## TOWNES AT HAGGERTY JZ25-42

### **JZ25-42 TOWNES AT HAGGERTY PRO PLAN WITH REZONING 18.753**

Public hearing at the request of The Avedon Company for initial submittal and eligibility discussion for a Zoning Map Amendment from Office Service and Office Service Commercial to High-Density Multiple Family with a Planned Rezoning Overlay. The applicant is proposing to develop a 175-unit townhome development.

## PLANNING REVIEW

PROJECT NAME: THE TOWNES AT HAGGERTY  
THRU, EMBL, CITY OF NOBLES AND COUNTY, MI  
SHEET TITLE: DEMOLITION PLAN

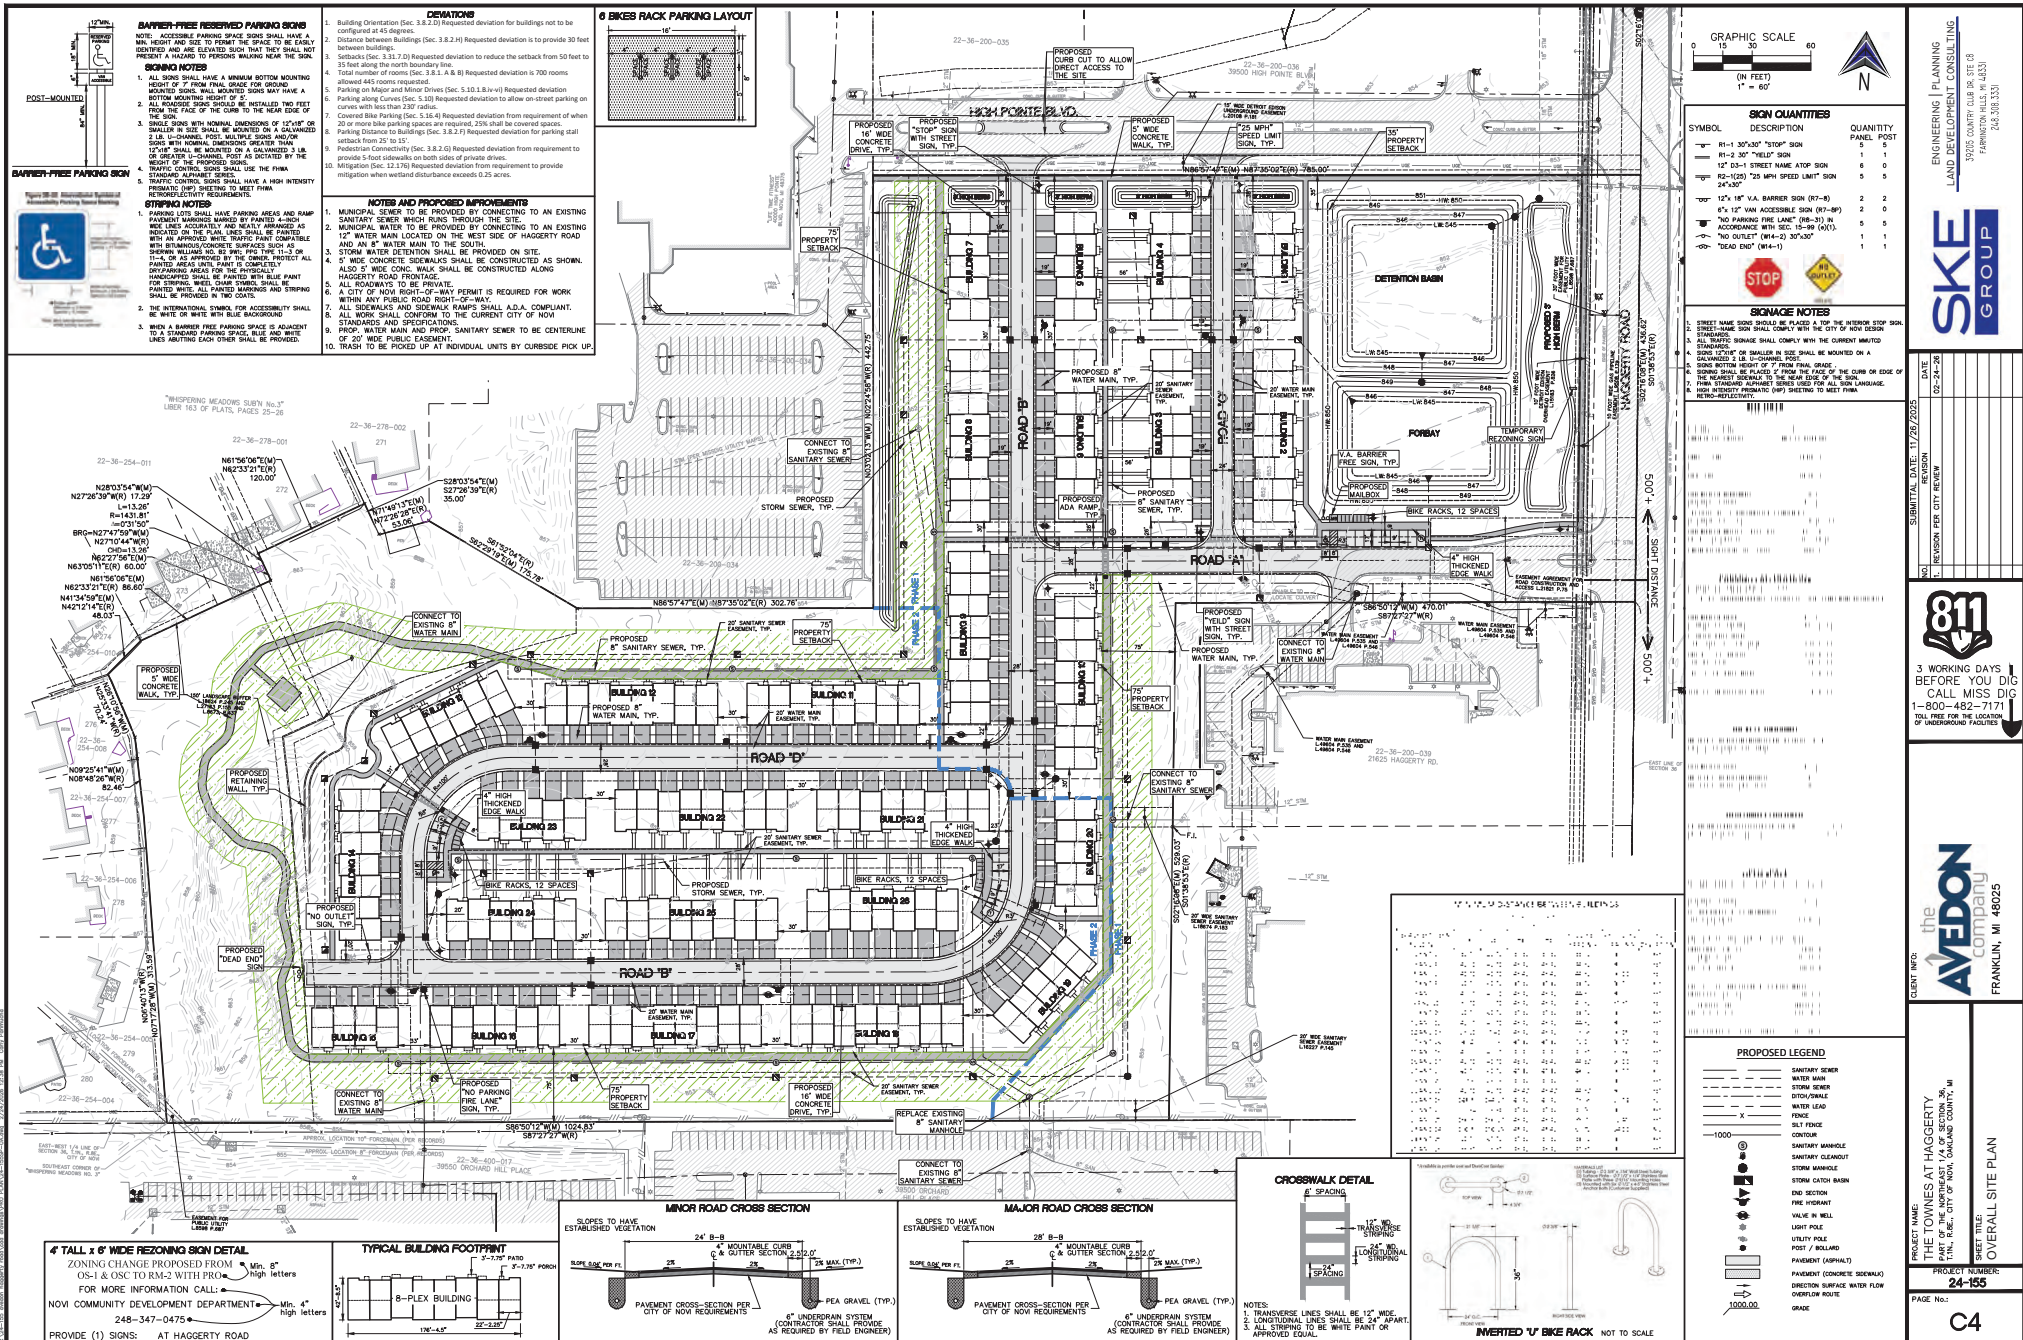
As noted in the plan set the site contains several heavily wooded areas. Sheet C3 indicates the majority of trees surveyed on the site will be removed. The tree inventory is included in the plan set on sheet L-8, and shows that 777 regulated woodland trees will be removed, resulting in 1,197 woodland replacement tree credits being required. Fifty-four tree credits are proposed to be planted on-site, with the remaining 1,143 credits to be paid into the tree fund.

1. The applicant has proposed impacting all wetlands on-site. The applicant has summarized all wetland impacts on Sheet C3 and they are summarized below in **Table 1**.

PROJECT NAME: THE TOWNHES AT HAGGERTY  
PROJECT NUMBER: 24-155  
SHEET TITLE: OVERALL SITE PLAN  
PAGE NO.: C4

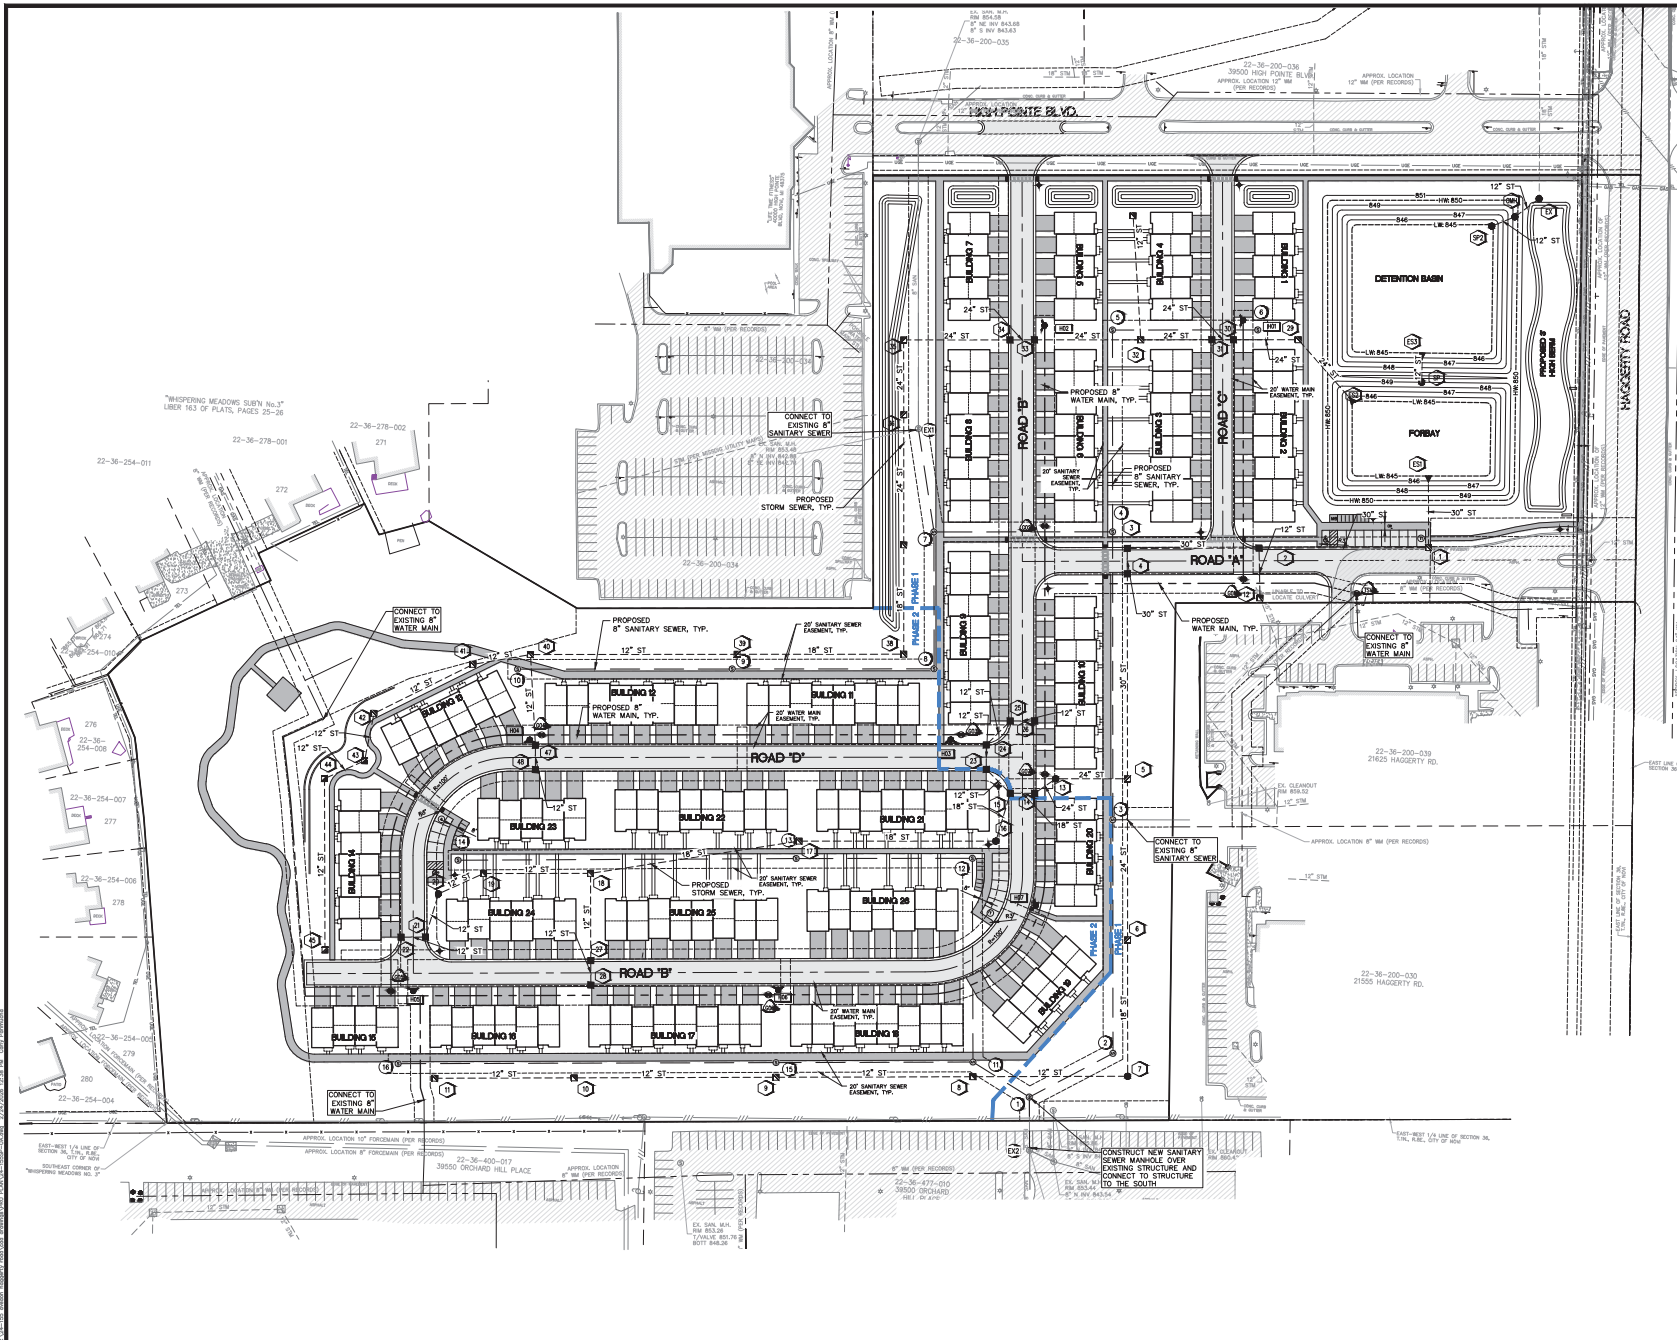
1. **Building Orientation** (Sec. 3.8.2.D): Deviation requested for buildings not to be configured at 45 degrees. The proposed orientation improves site efficiency, preserves open space, and enhances functional lot layout. **Staff supports this deviation, as we have in several recent projects.**
2. **Distance between Buildings** (Sec 3.8.2.H): Deviation requested to provide 30 feet between buildings. This spacing maintains adequate light, air, and emergency access while allowing efficient site design. **The Ordinance requires building separation distances from the calculated formula based on the buildings' height and length. The applicant provides these calculations on sheet C4, which shows required distances range from 31.28 to 85.7 feet.**

- g. **Sign Location Plan:** Wording and size of signage is indicated on sheet C4 and meets the requirements. The location indicated on Haggerty Road is approved. **Signage will need to be posted prior to public hearing.**

4. **Usable Open Space:** Sheet C4 indicates areas of Usable Open Space Plan. Each unit will have a deck 36 square feet in size. For phase 1, the only area of usable open space is the building setback area adjacent to an 8-foot pathway, which includes a portion of a storm water trench. In Phase 2 the applicant calculates the area as 2.4 acres, which is also all essentially a buffer area around the walking path through the landscape easement on the west side. This trail appears to be very steep in some areas, and so may not be accessible to all residents. **The use of a buffer area around the trail for the entire usable open space does not meet the intent of the ordinance, even though the calculation shows they exceed the requirement. The applicant should attempt to locate additional open space areas easily accessible to Phase 1 that will not be inaccessible while Phase 2 is under construction. A development of this size, with an estimated 100 children, should have at least one playground amenity since there are no parks in this area of the city. The applicant should also verify that the existing greenbelt easement will allow the trail to be constructed through it.**

Sidewalk Ramps – Proposed ramps have been added to the plans, see sheet C4.

End Islands – Radius labels have been added to the plans, see sheet C4.

Parking space front curb height – Phase 2 has been updated to match Phase 1, see sheet C4.

Bicycle parking – Dimension for sidewalk in front of spaces has been labeled for 6’ clear path, see sheet C4.

Signing and Striping – The duplicate signing notes have been removed, see sheet C4.

Signing and Striping – A “Dead End” sign has been added, see sheet C4.

L-1

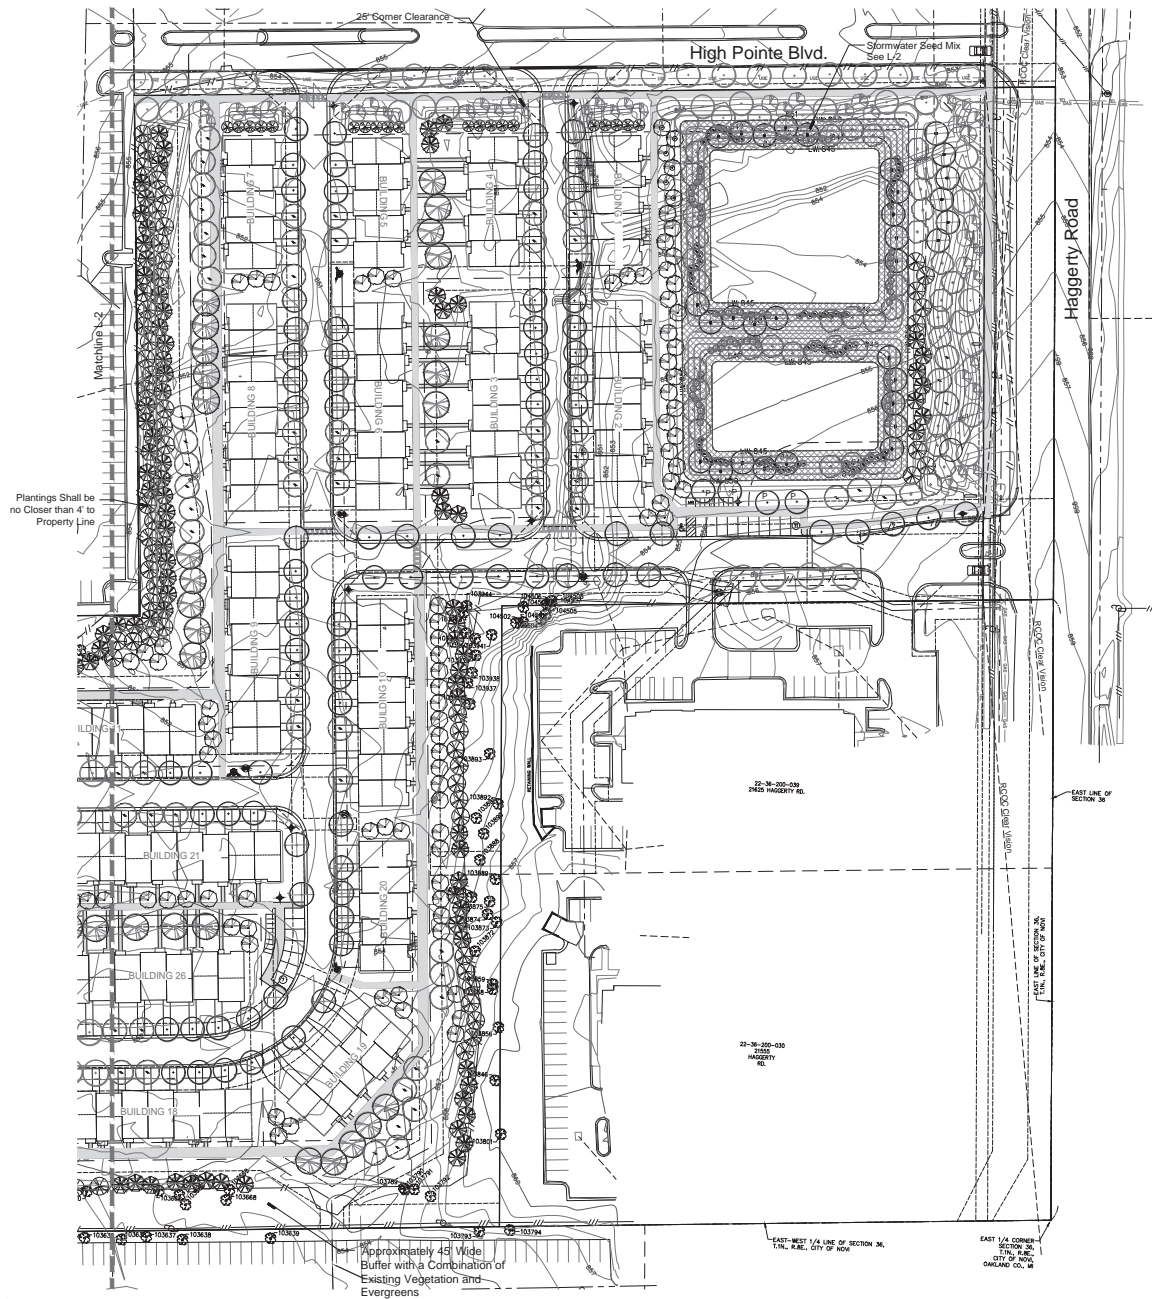
<ul style="list-style-type: none"> <li>• <b>Deviation for lack of street trees on Haggerty and possibly on internal roads due to utilities</b> (<i>Not Supported for internal roads</i>)</li> </ul>
Wetlands	<b>Concerns Noted</b>	3-24-26	<ul style="list-style-type: none"> <li>• <b>Significant areas of regulated wetlands on the site – impacts to entire 4.35 acre</b></li> <li>• <b>Wetland permits required</b></li> <li>• <b>Deviation requested to not mitigate wetland impacts</b></li> </ul>
Woodlands	No Significant Concerns	12-16-25	<ul style="list-style-type: none"> <li>• <b>Greater on-site planting of woodland replacements encouraged</b></li> <li>• Items to be addressed on subsequent submittals</li> </ul>
Traffic	<b>Concerns Noted</b>	3-23-26	<ul style="list-style-type: none"> <li>• <b>Deviation for parking along street with centerline radius less than 230-ft</b></li> <li>• <b>Deviation for parking on a major drive</b></li> <li>• <b>Deviation for lack of covered bicycle parking</b></li> <li>• <b>Deviation for deficiency in 5-foot sidewalks on private drives</b></li> <li>• <b>Deviation for absence of an eyebrow in areas with radius below 230-ft</b></li> <li>• <b>Deviation for deficiency of 6-ft clear path to bike parking</b></li> <li>• Items to be addressed in Site Plan submittals</li> </ul>

- Requested Waivers:
1. Landscape Waiver from Sec. 5.5.3.B.ii for Deficiency of Required Haggerty Road Street Lawn Trees Due to Existing Watermain. Trees will be too Close to the Sidewalk or Street to Maintain Planting Separation from the Utility.
